REMARKS

Regarding the status of the present application, Claim 9 has been canceled, Claim 1 has been amended, and Claims 1-8 and 10-18 are pending in this application. Reconsideration of this application is respectfully requested. A Petition and fee for a two month extension of time is enclosed. It is respectfully submitted that the present response does not require further searching on the part of the Examiner. It is also respectfully submitted that this response places this application in condition for allowance, or in any event, places it in better condition for consideration on appeal.

Fig. 4a

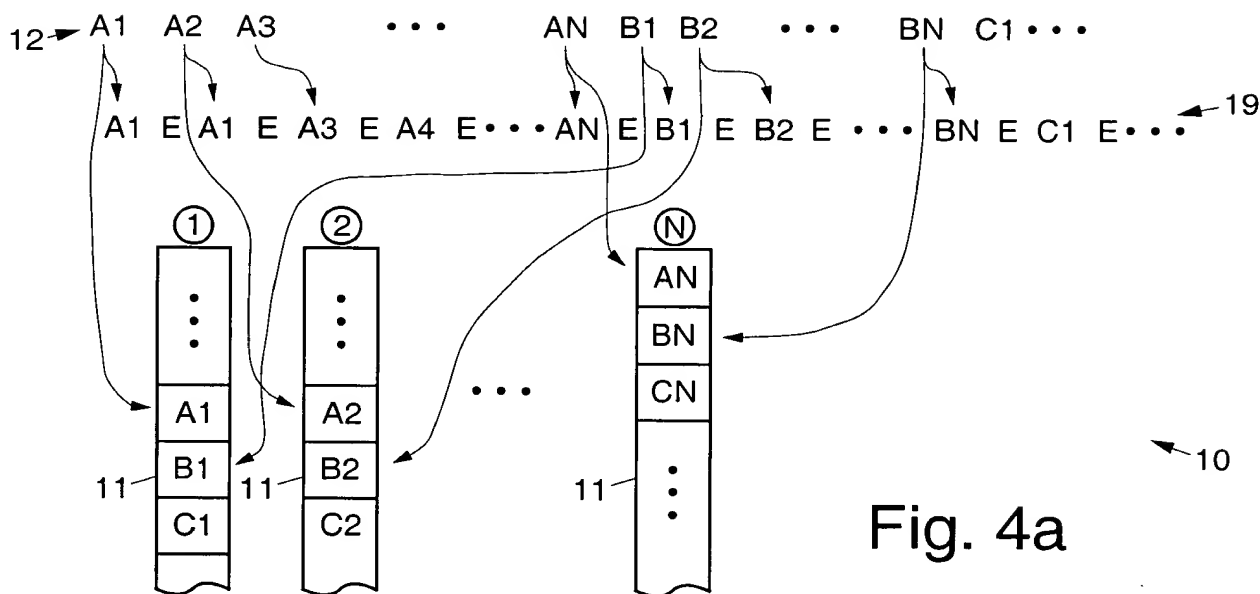
As to the Examiner's issue regarding pages 17 and 18 and Fig. 4a that "numerous references to Fig 4a showing a "device 10" appear to be inaccurate", reference numeral 10 at the right side of the figure identifies the device. Reference number 11 in Fig. 4a identifies data registers 11, which are clearly part of a device. Reference number 12 in Fig. 4a identifies a data stream 12 which is processed by the device 10 using the data registers 11. Reference number 19 in Fig. 4a identifies an output transmission stream 19 which is output from the device 10. All of the elements shown in Fig. 4a relate to a device. It is therefore respectfully submitted that Fig. 4a illustrates a device 10, and the specification is correct.

Fig. 6

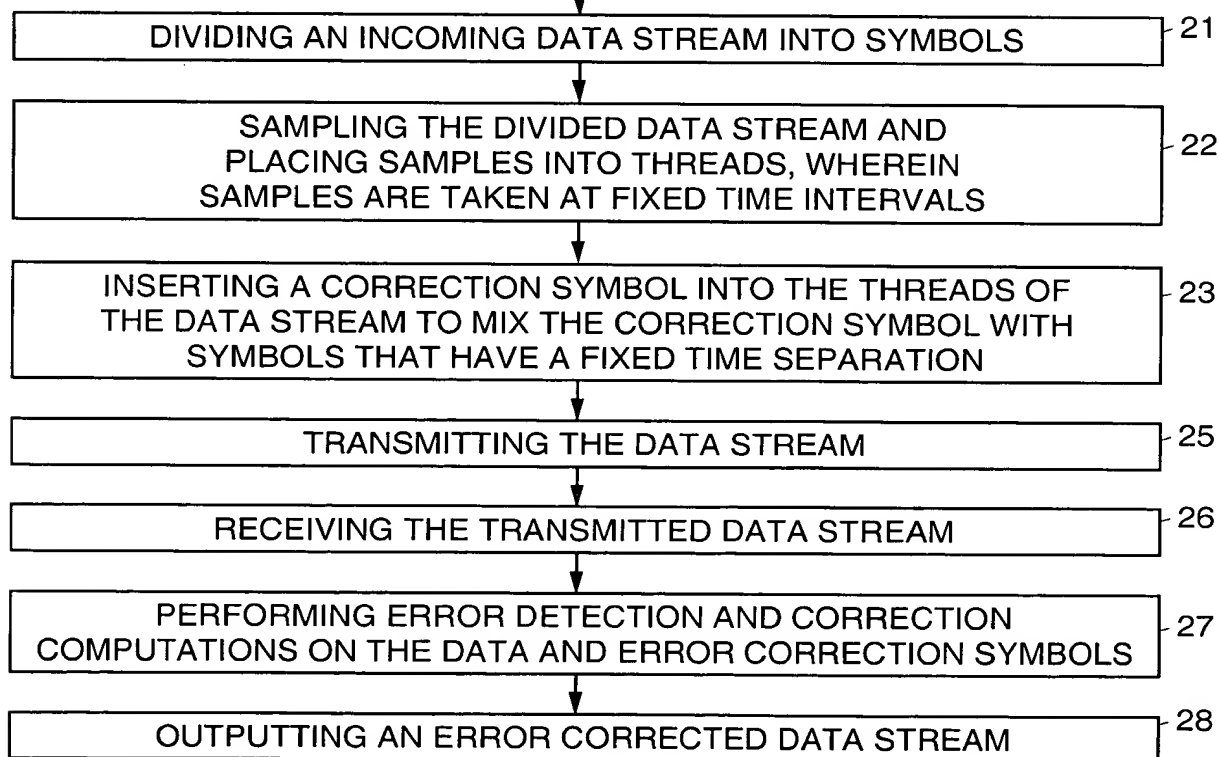
The drawings were objected to because reference numeral "10" should be "20" in Figs. 5 and 6. It is respectfully submitted that Figs. 5 and 6 have been amended to correct the numbering error. Enclosed is a marked up drawing showing proposed amendments marked in red ink. Also enclosed is a replacement reproducing master containing the amendments. Withdrawal of the Examiner's rejection of Claims 1-18 is respectfully requested.
